ARCHITECTURAL REVIEW BOARD STAFF REPORT

Project #/Name	**ARB-2020-69: Sleep Number Initial Site Plan**
Review Type	Initial Site Development Plan
Parcel Identification	06100-00-00-134A0
Location	South of Fashion Square Drive, north of 1425 Seminole Trail
Zoned	Planned Development Shopping Center (PDSC)/Entrance Corridor (EC)
Owner/Applicant	Albemarle Bank & Trust CO C/O BB&T Property Tax Compliance/Collins Engineering (Scott Collins)
Magisterial District	Rio
Proposal	To construct a mattress store with associated site improvements.
Context	The site is a wooded lot surrounded by commercial development. Fashion Square Mall is to the north and east, with the eastern property line of the subject parcel adjacent to mall parking. The 29th Place shopping center is across Rt. 29 to the west. Banks are located to the south and southwest. The Branchlands planned unit development is to the east and southeast.
Visibility	The proposed development will be readily visible from the EC street.

ARB Meeting Date	July 20, 2020
Staff Contact	Margaret Maliszewski

PROJECT
SLEEP NUMBER - CHARLOTTESVILLE FINAL ARB PLAN
LIGHTING PLAN
SHEET

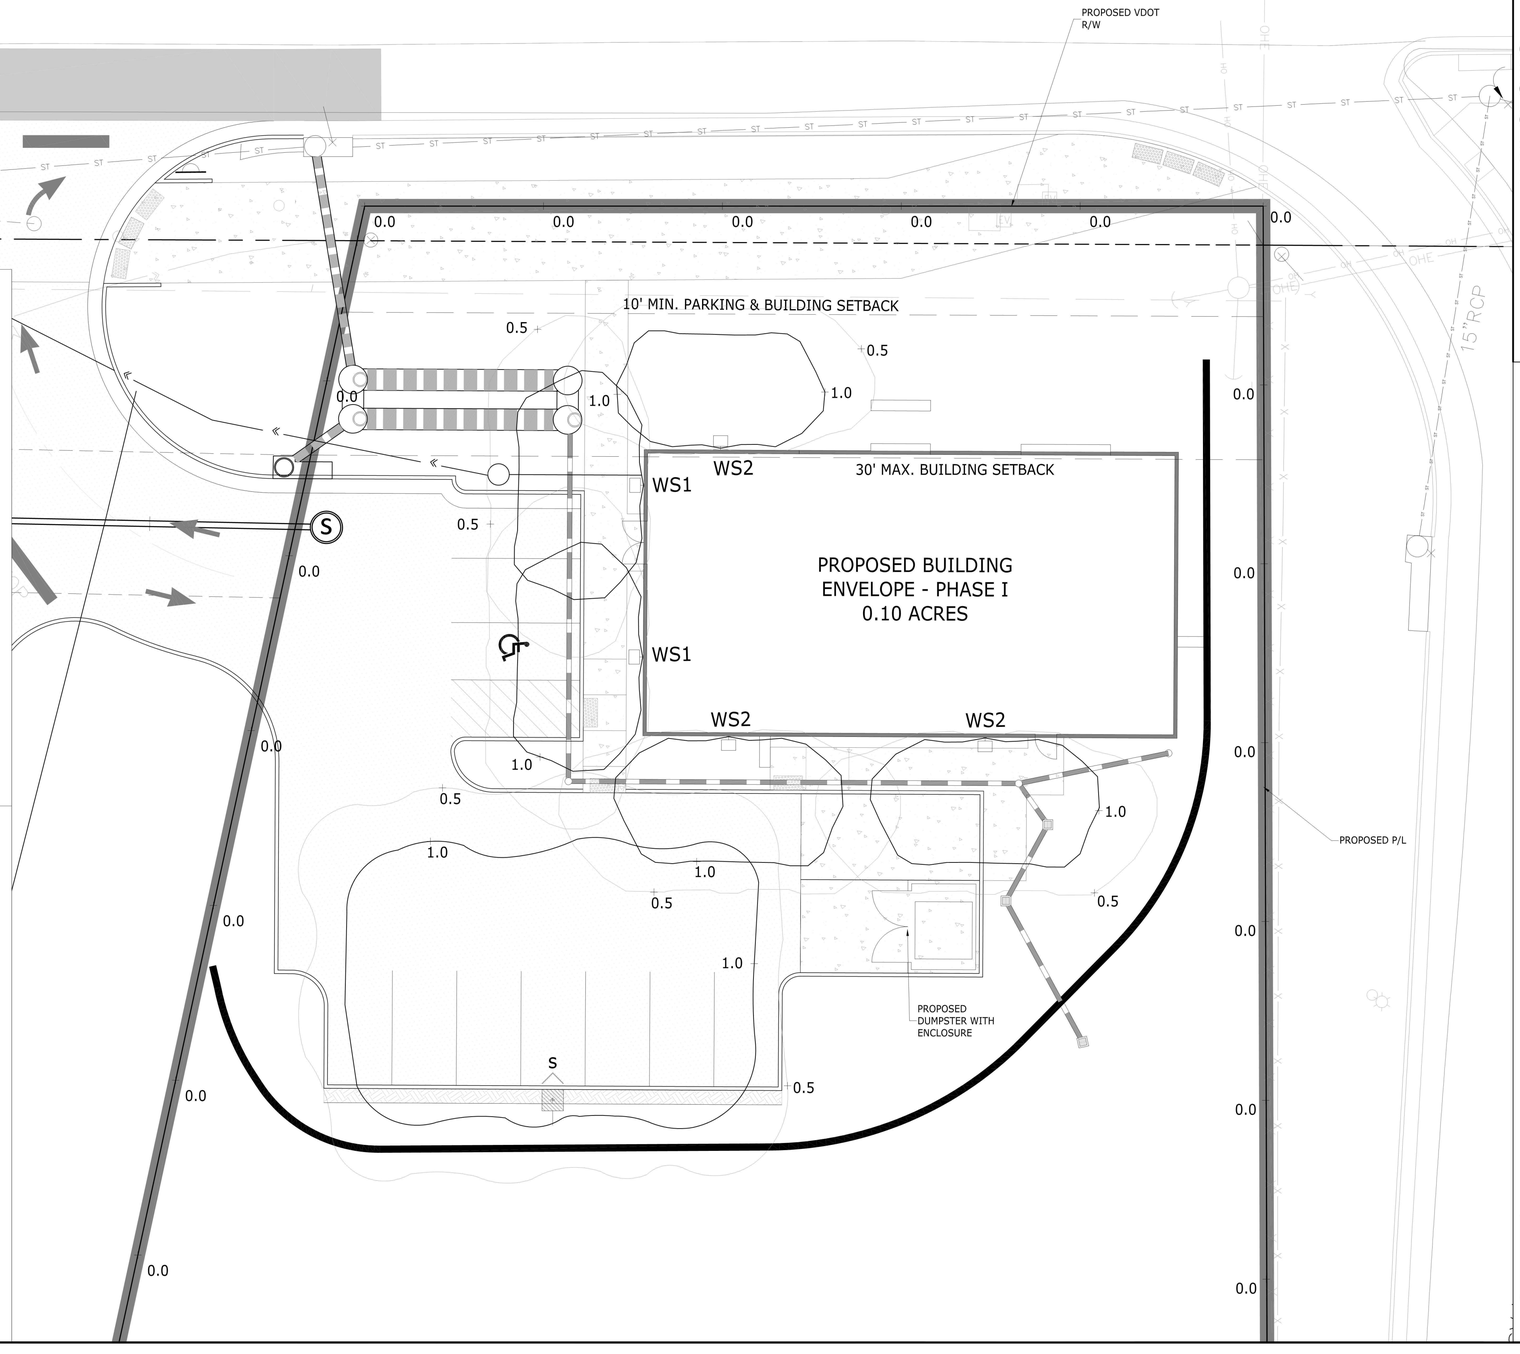
6. Revise the photometric plan to provide illumination values using the point-by-point method and indicate the maximum fc value.
7. Revise the lighting plan to indicate the color temperature of the pole light. The color temperature must be 3000K or less.

8. Revise note 4 under the Luminaire Schedule to indicate that light fixtures will have lamps emitting warm white light.
9. Coordinate note 5 under the Luminaire Schedule with the color identified in the cut sheet for the wall fixtures. Ensure a consistent color for all fixtures.

ROOF PLAN - SLEEP NUMBER STORE

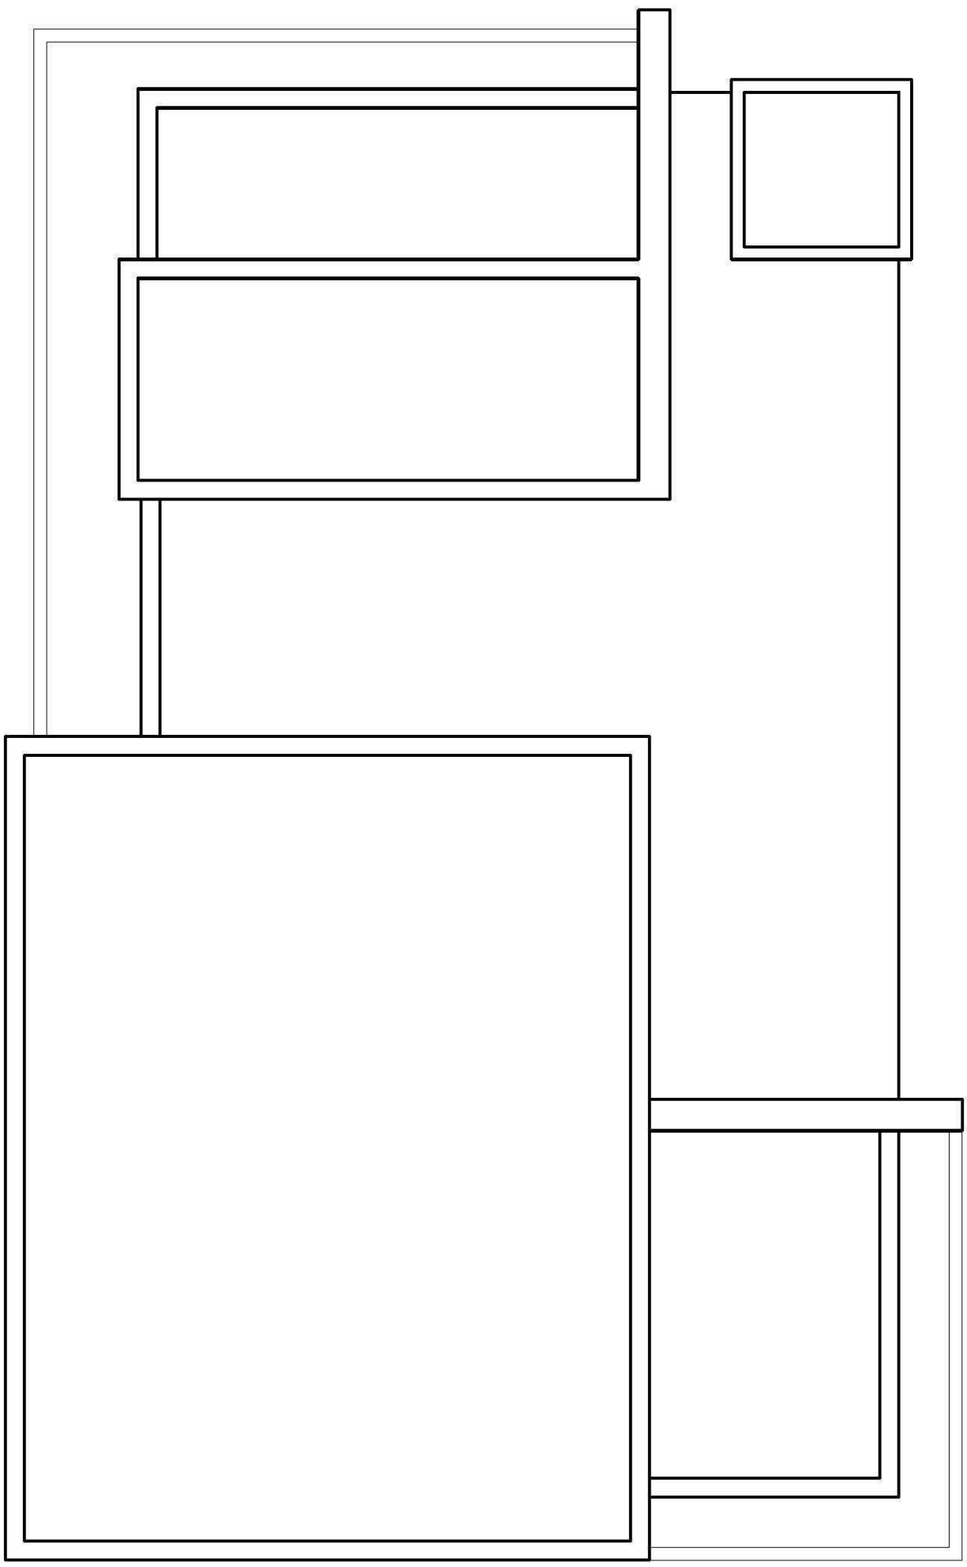
4. Revise the architectural design to reflect the traditional architecture of the area.
5. Revise the plans to show the locations of all mechanical equipment. Show how visibility of the equipment will be eliminated from the EC.

1 LEFT ELEVATION BEYOND WALL
1/8"=1'-0"

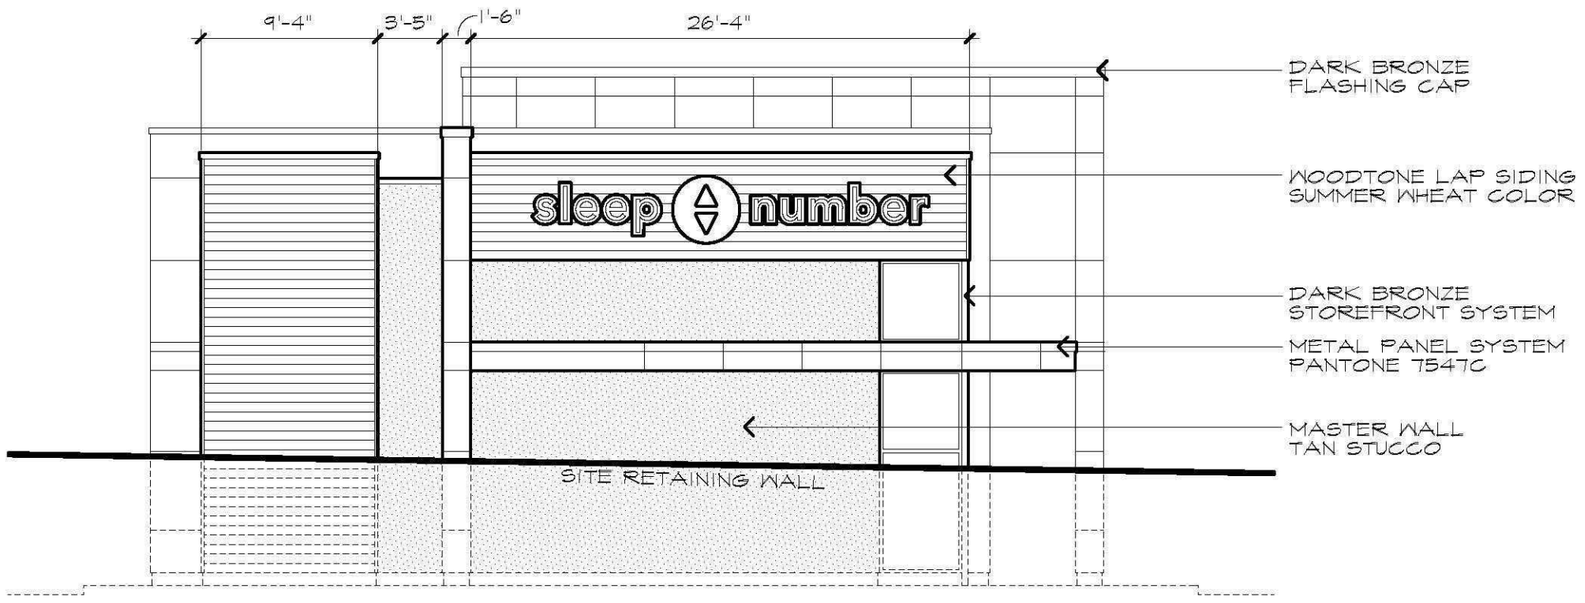
The "Left Elevation Beyond Wall" drawing shows that the retaining wall on the north side of the property hides approximately 6' of the lower part of the north elevation. Shrubs and small trees are shown along the north side of the property, at the top of the retaining wall. The perspective renderings show that this landscaping and the topography will provide additional screening. These plants, combined with the revised architectural design, are expected to provide an appropriate appearance.	
37	Plant species: a. Plant species required should be as approved by the Staff based upon but not limited to the *Generic Landscape Plan Recommended Species List* and *Native Plants for Virginia Landscapes (Appendix D)*.	Provide a complete landscape schedule with the Final Site Plan.	A landscape schedule has been provided. The proposed plant species are found in the various lists.	None.
38	Plant health: The following note should be added to the landscape plan: "All site plantings of trees and shrubs shall be allowed to reach, and be maintained at, mature height; the topping of trees is prohibited. Shrubs and trees shall be pruned minimally and only to support the overall health of the plant."	Add the plant health note to the site plan.	The note appears on the landscape plan.	None.
